## VANGUARD 7300 SERIES HARDWARE ADVISORY NOTICE Release 6.1.T14A

### Vanguard 7300 CPU Card Upgrade

**Figure 1. Part Number Label**

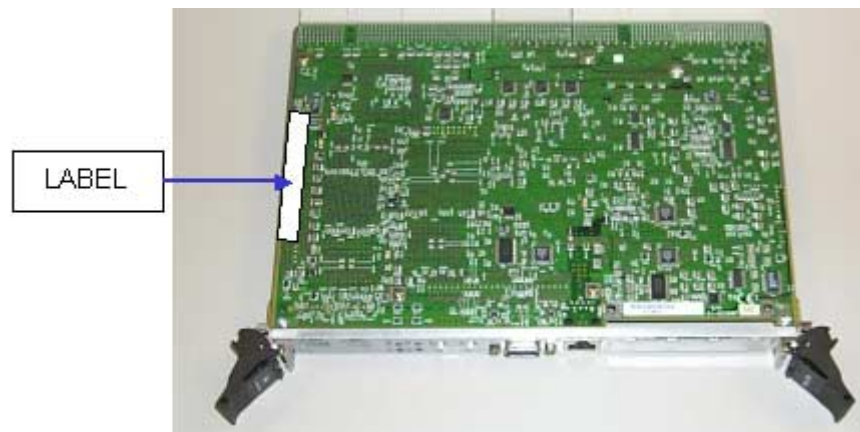
Figure 1 shows the revision label, located on the side of the unit.

The Vanguard 7300 Series MCP750 (part number 75836G02) system cards are supported by software releases 6.1.T14A and greater. If you have a part number 75836G02 system card and are running older versions of release 6.1, a new 6.1 software patch is required (6.1.T14A). The system cards have a different revision PCI-PCI bridge than previous system cards (part number 75836G01). The new system cards are not being recognized by software older than 6.1.T14A. Software patch 6.1.T14A must be installed when using part number 75836G02.
